## **FAX TRANSMITTAL**

**Subject** Horton Drivemaster 989012/999012

OLD MOUNTING  
 LOCATION  
 FOR HORTON 999012

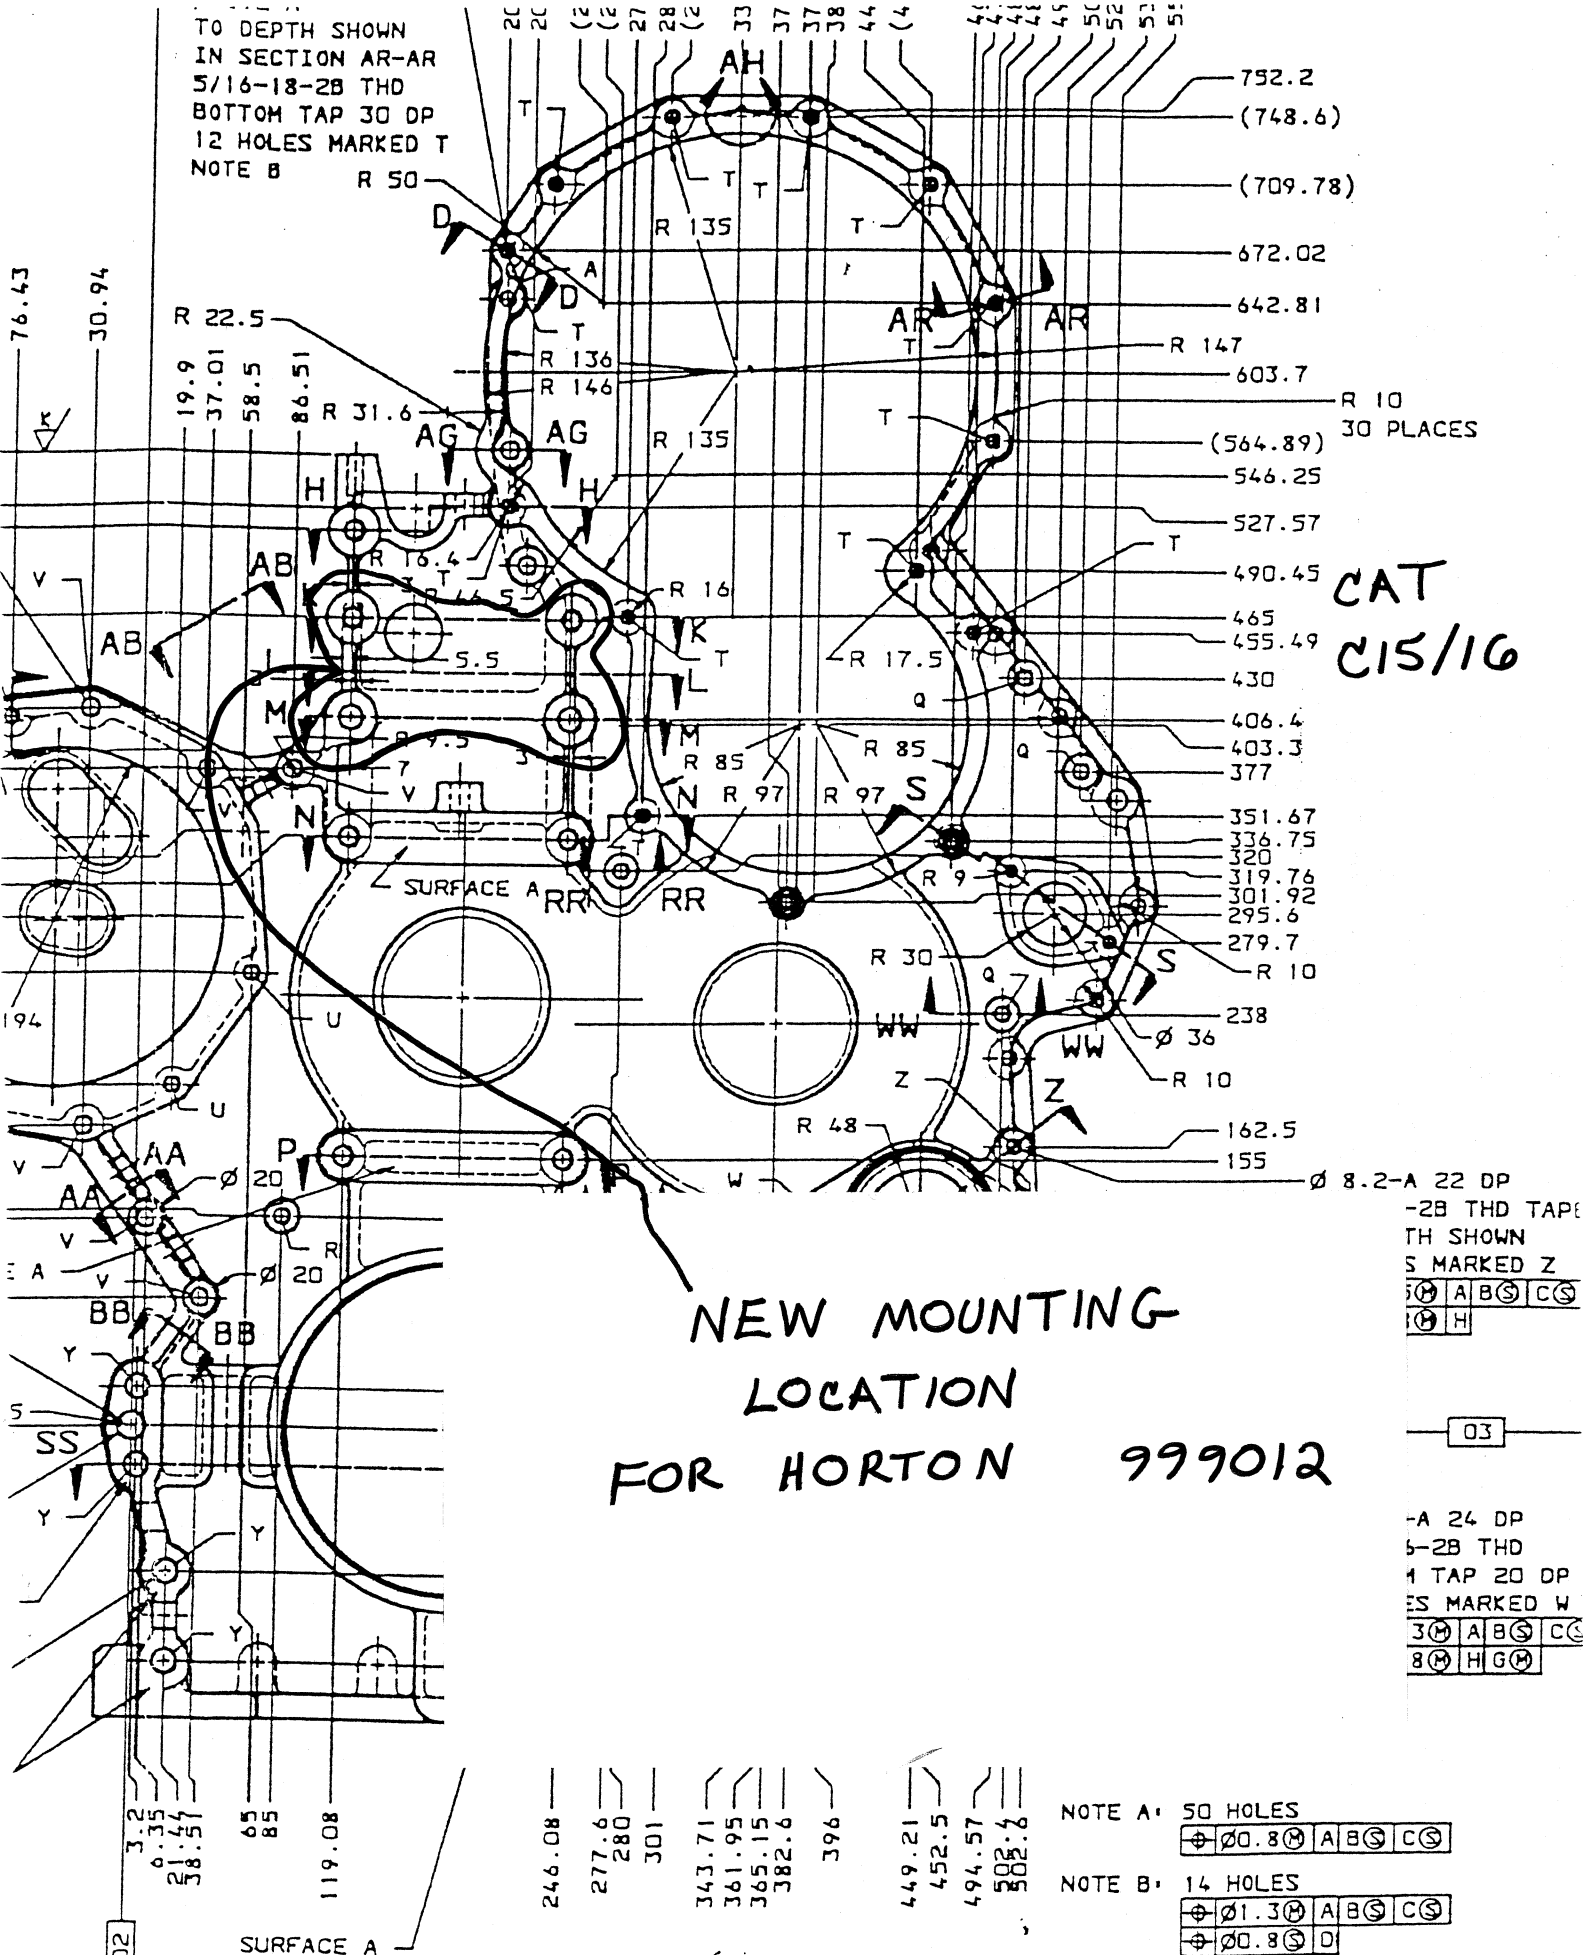
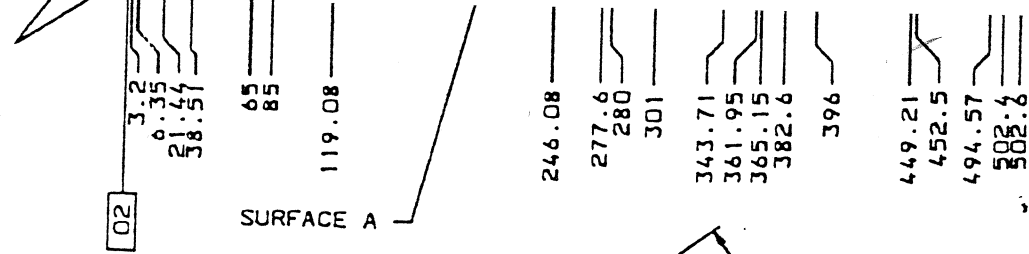
In August of last year, per Peterbilt's request, Horton changed the journal bracket on the 999012. This was done so that during engine dress Horton and Borg-Warner fan drives would share the same engine mounting stud locations. The fan center did not change when the new journal bracket was implemented only the mounting location.

What mechanics are encountering during service is that the replacement fan drive has the new bracket, which uses different mounting holes on the engine.

DriveMaster 999012's built before Serial # 2790699 use the old bracket; therefore, replacement with current production 999012's requires relocating the engine-mounting studs. (See accompanying drawings for clarification)

NEW MOUNTING  
LOCATION  
FOR HORTON 999012

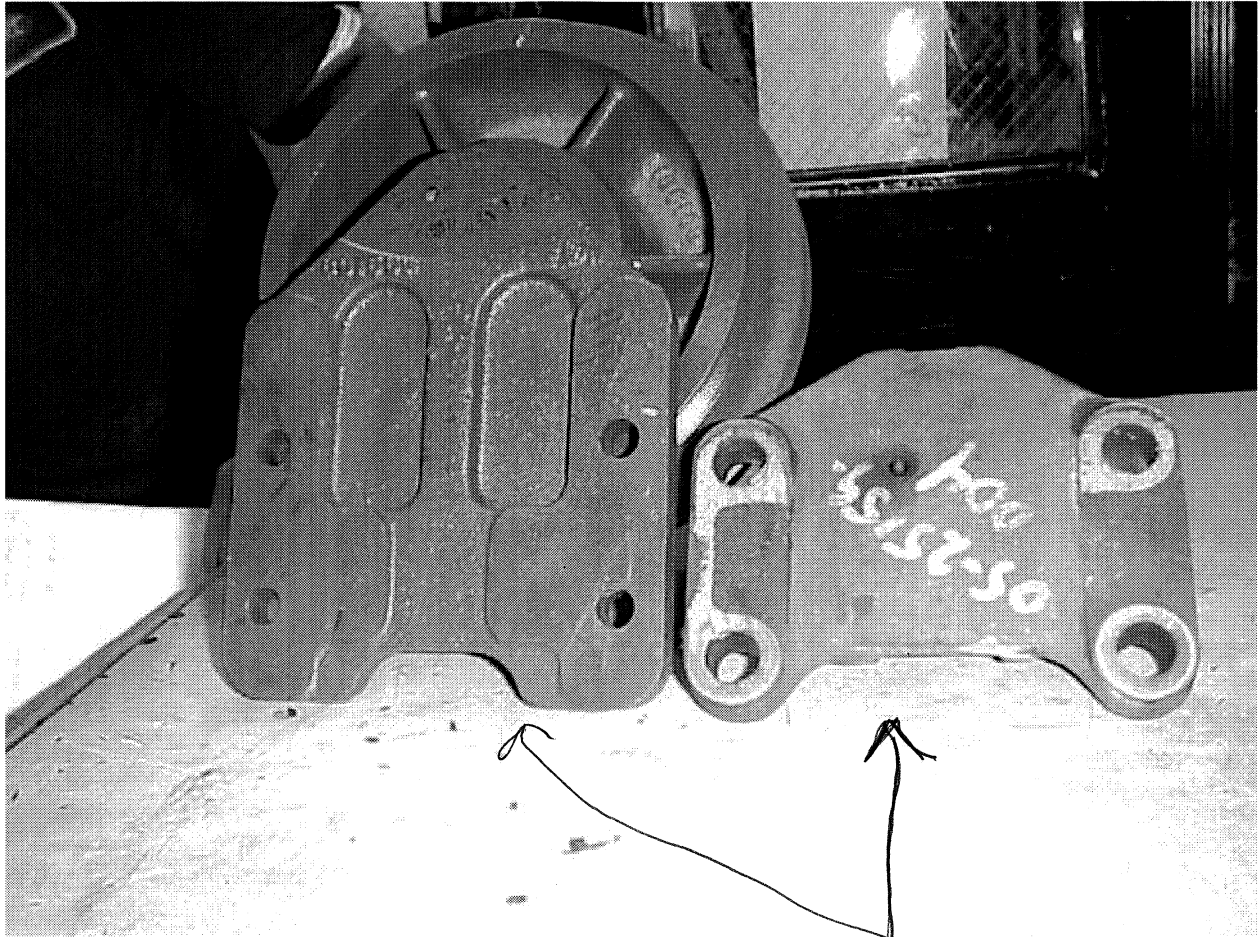
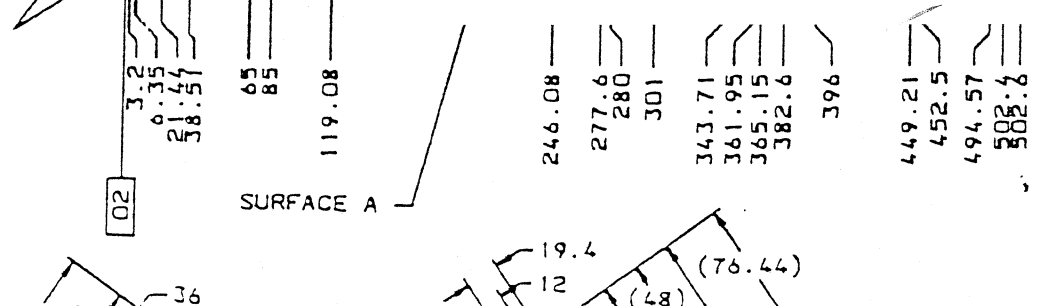
AUG 00 changed brkt. FROM TO.
